**Area Walk-By Checklist (AWC)**

Fermi 2 Seismic Walkdown Guideline  
Area Walk-By-Checklist

NJPR-12-0043

(DSCN0210)

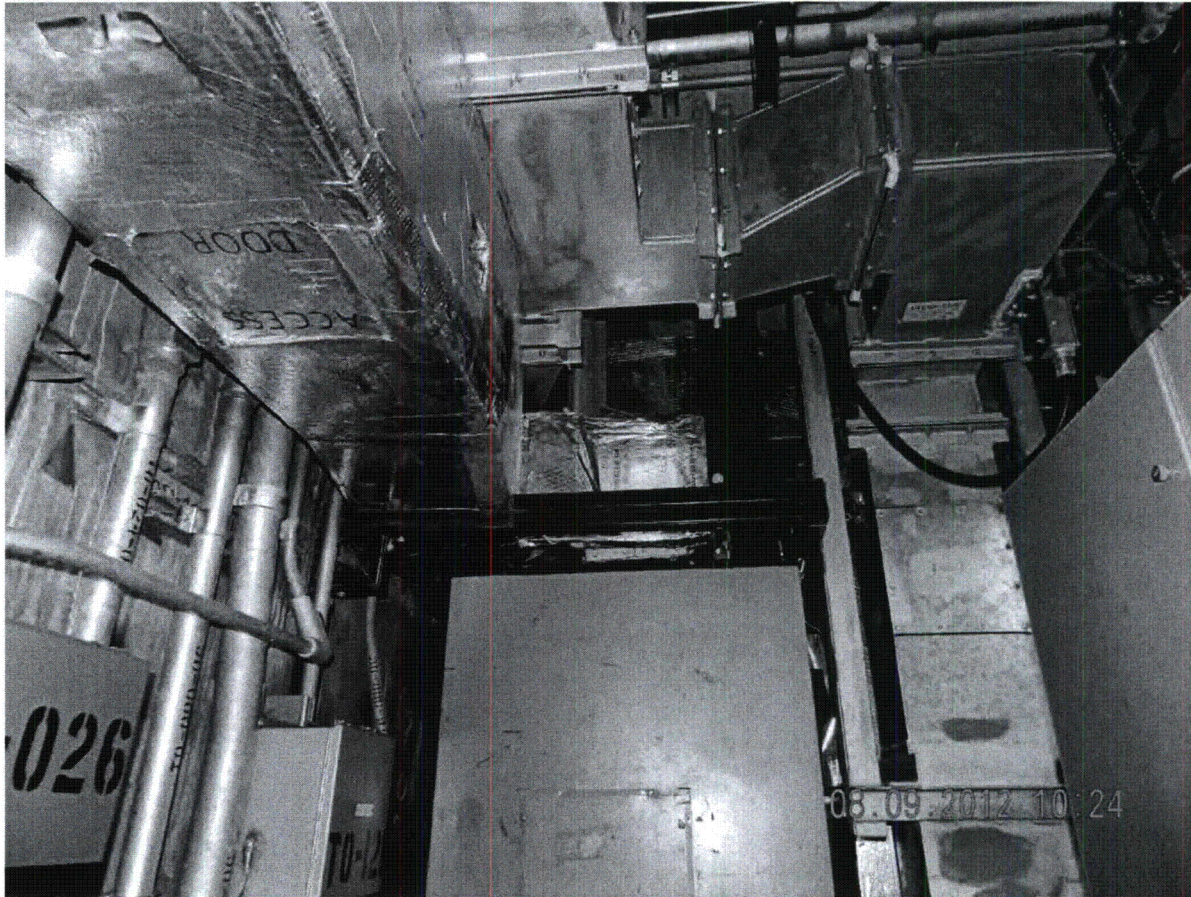
*All items above cabinet, copper pipe, tube track and HVAC ducts appear seismically supported. Copper pipe connected to valves P50F701 & P50F377, part of instrument air system.  
(See Photo DSCN0209, DSCN0210 and DSCN0224)*

*HVAC ducts are seismically supported. Instrument air tube-track and copper header pipe is seismically supported.  
(See Photo DSCN0210)*

(DSCN0211)

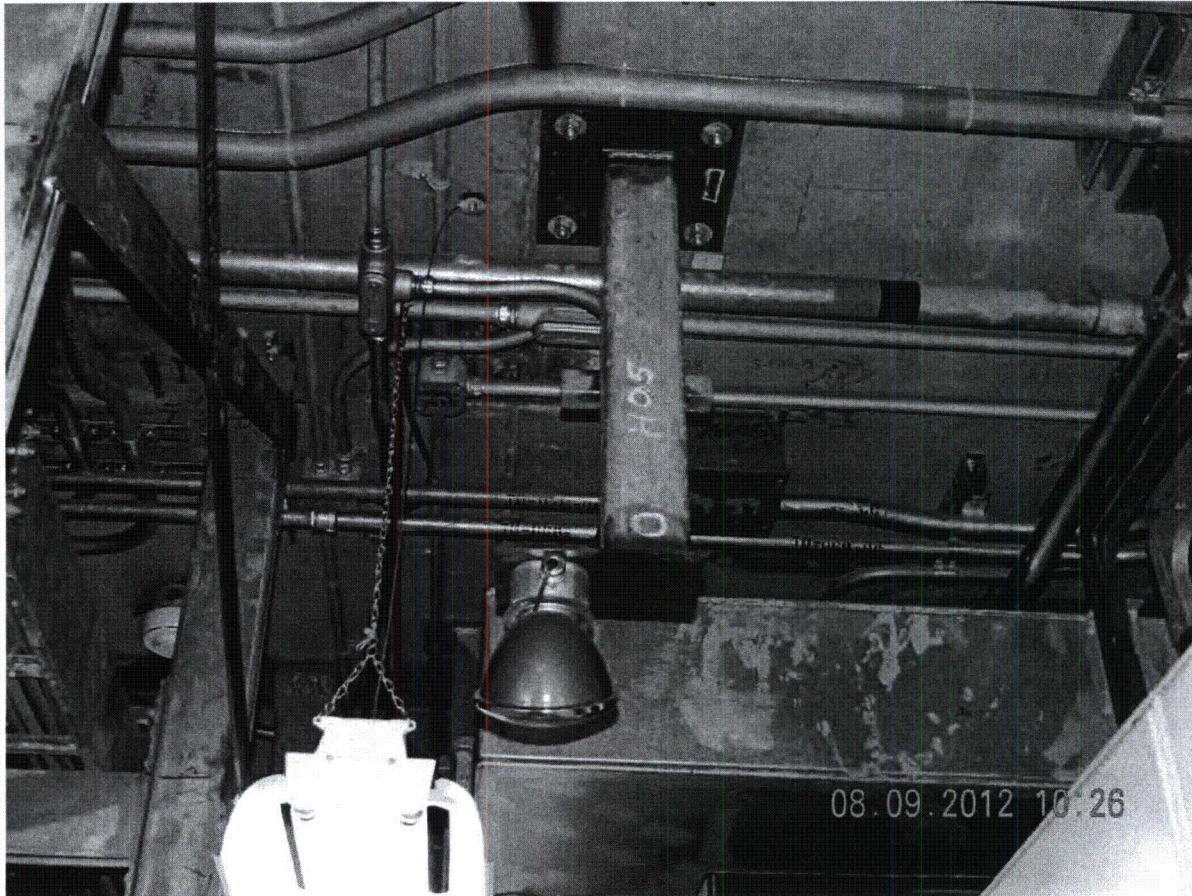
*No ceiling tiles in this area. Lights hung with chain and redundant wire.*

(DSCN0224)

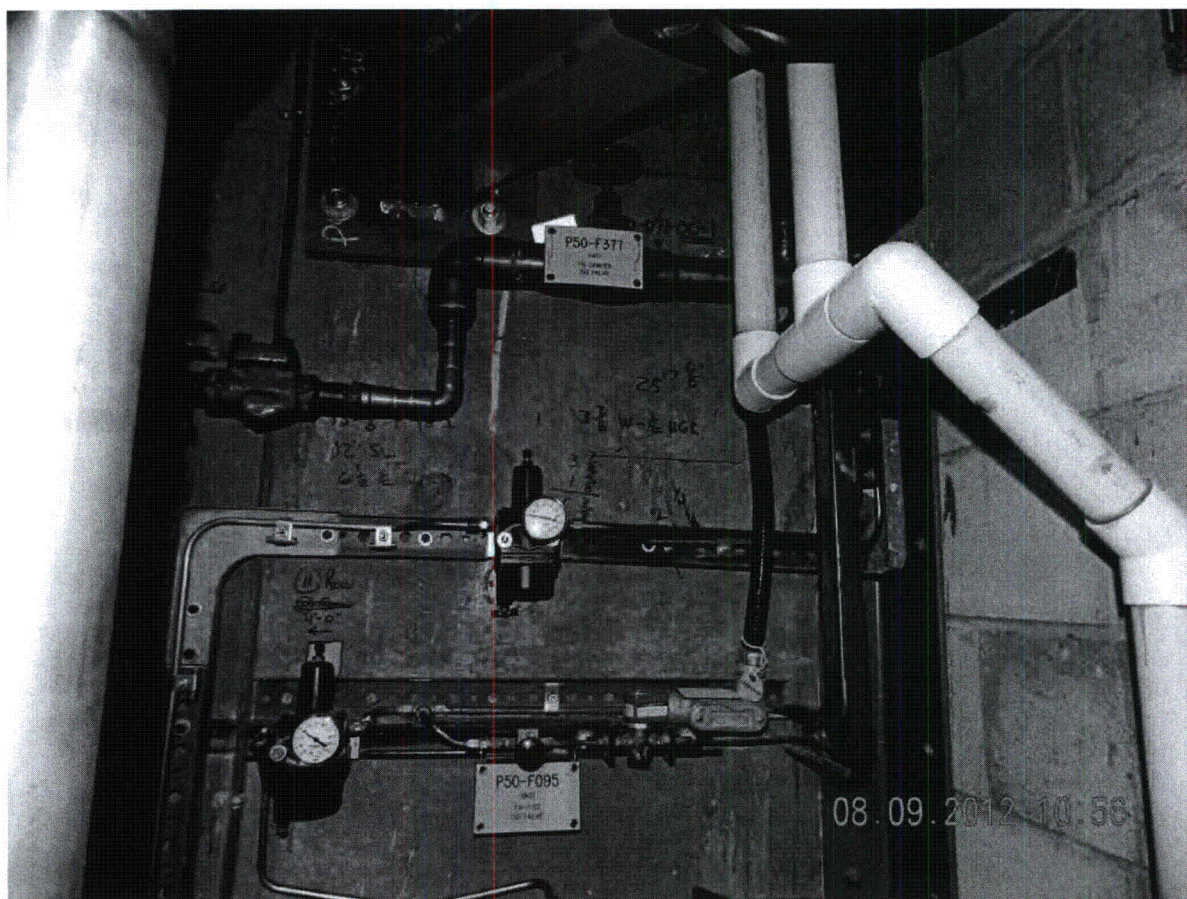
*Adjacent fire wall anchored to the floor. Adjacent Div. I cabinet anchored to the floor. Air handling unit T4100B033 approximately 15" from R3200S016 evidence of corrosion at the base. Corrosion is minor, and condensation moisture issues are being addressed by placement of absorbent socks at condensation location.  
(See Photo DSCN0209, DSCN0208, DSCN0217 and DSCN0224)*

(DSC00075)

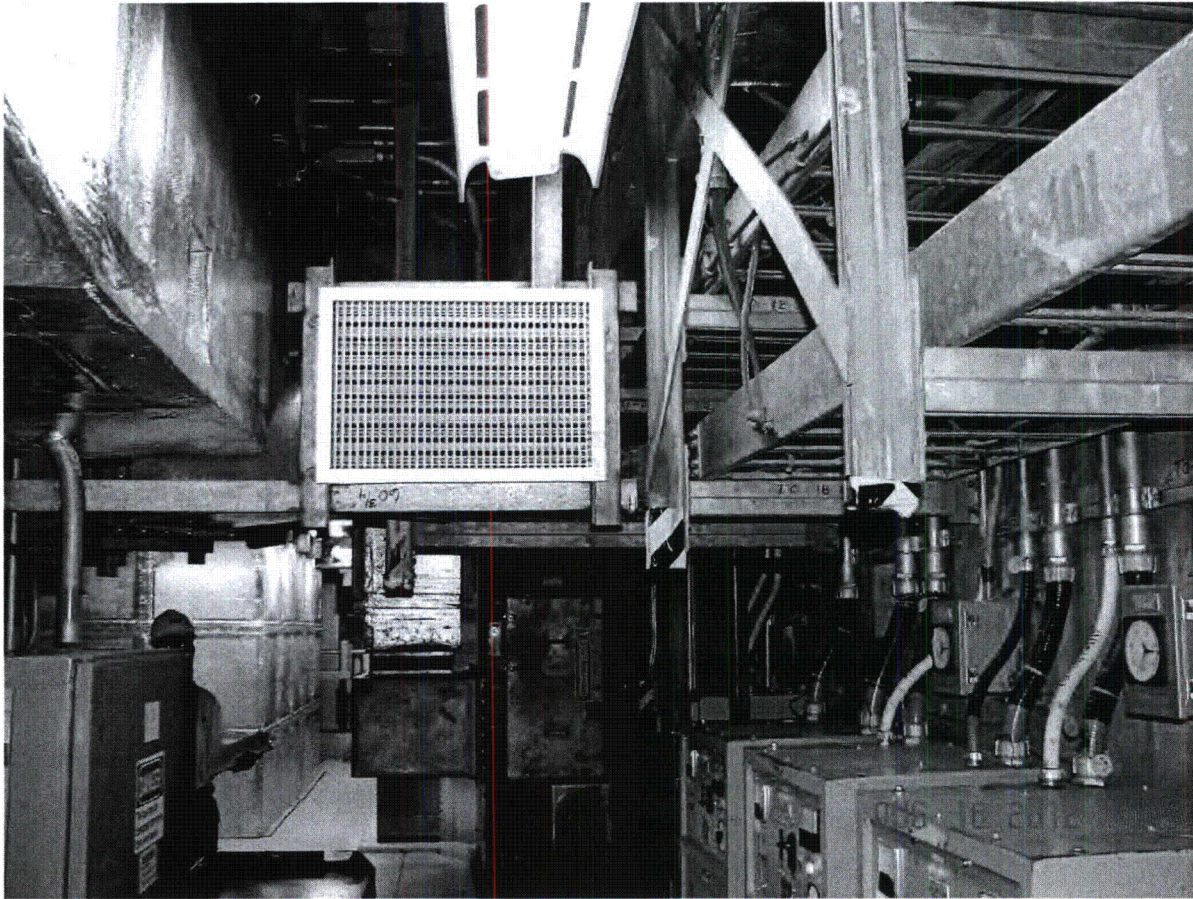
*No ceiling tiles in the area, lights hung on chains with redundant cable. (See Photo DSC00075)*

(DSCN0495)

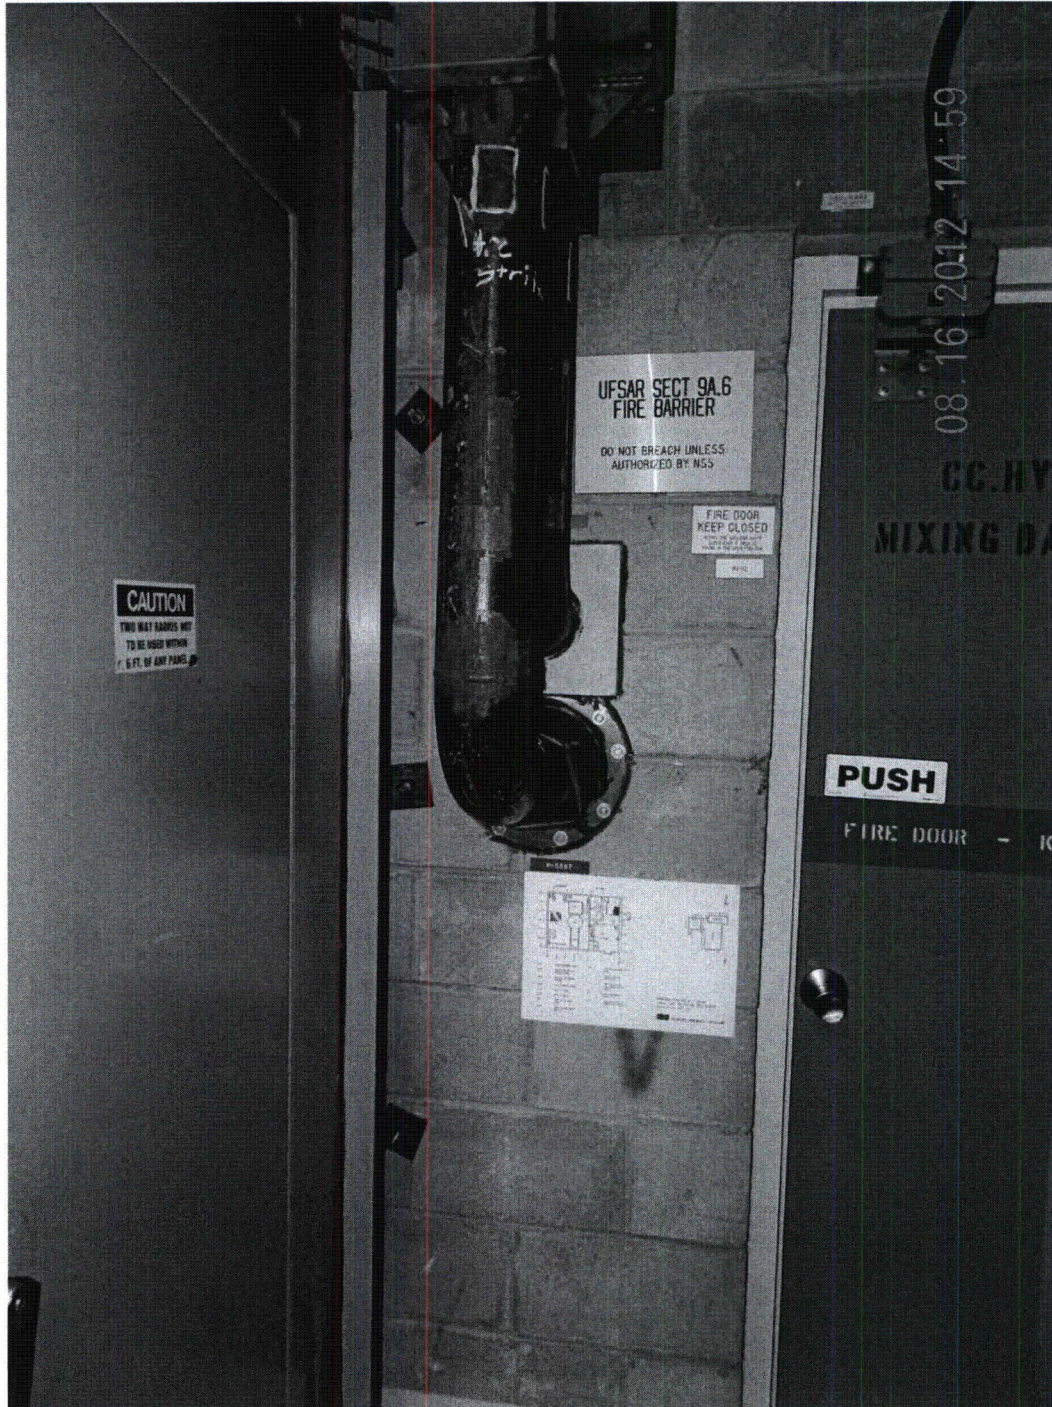
*Water piping to chiller is seismic. (See photo DSCN0495) Floor drain stand-pipe located by T4100B009 is shown extending 1-1/2" above the floor per Detail D1 of Dwg. M-2221, Rev. Q. Field condition reflects the floor drain stand-pipe extending 8-1/2" above the floor. CARD 12-27556 was written to address this "As-Built" condition and dispositioned under TSR-37042, Rev. 0.*

(Picture B2)

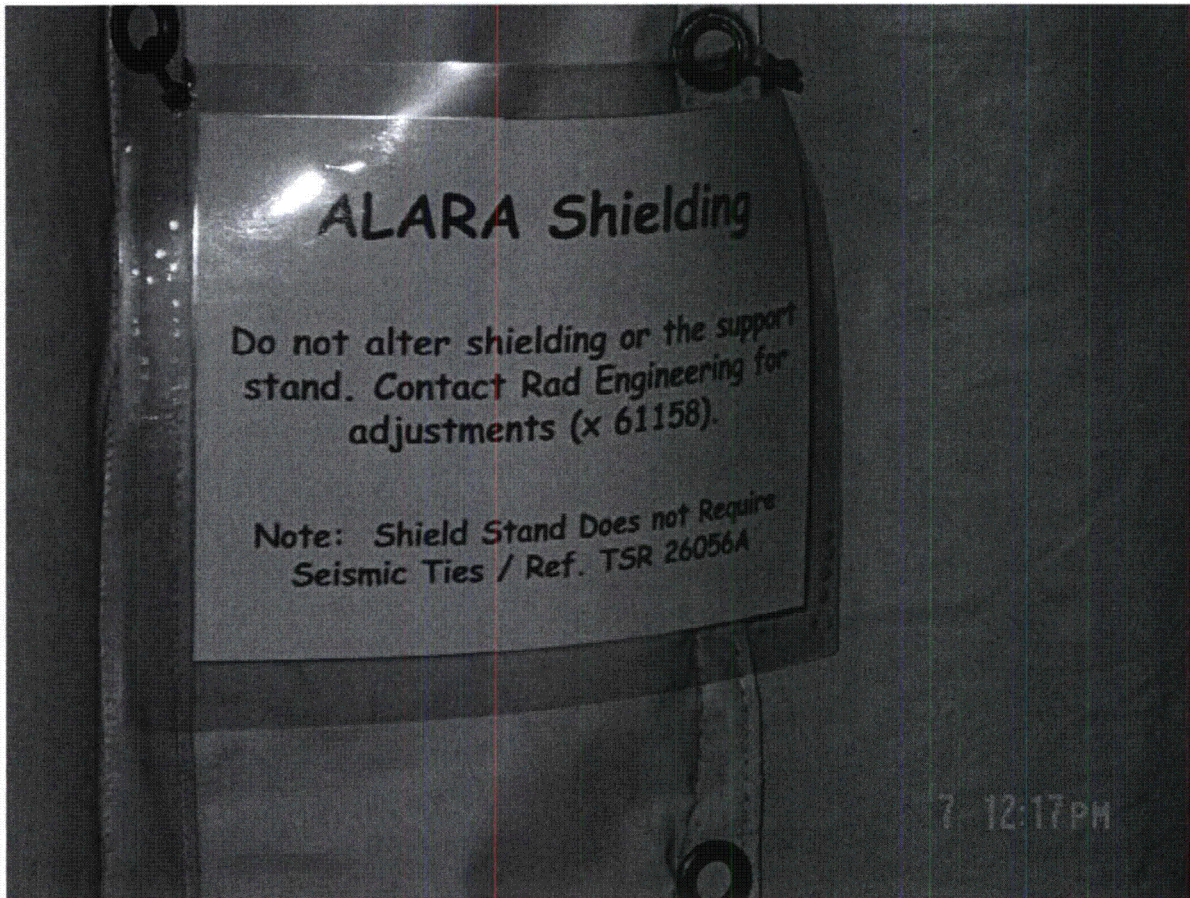
*Ladders south of E4150F001 are not secured to the wall racks by cables per MOP23. Per Specification 3071-544 and drawing C-2585 the wall mounted ladder racks are acceptable without cable restraints. Shielding at southwest corner is not anchored to the floor however it's noted that shield stand does not require seismic ties per TSR 26056, revision A. (See pictures B1 & B2.)*
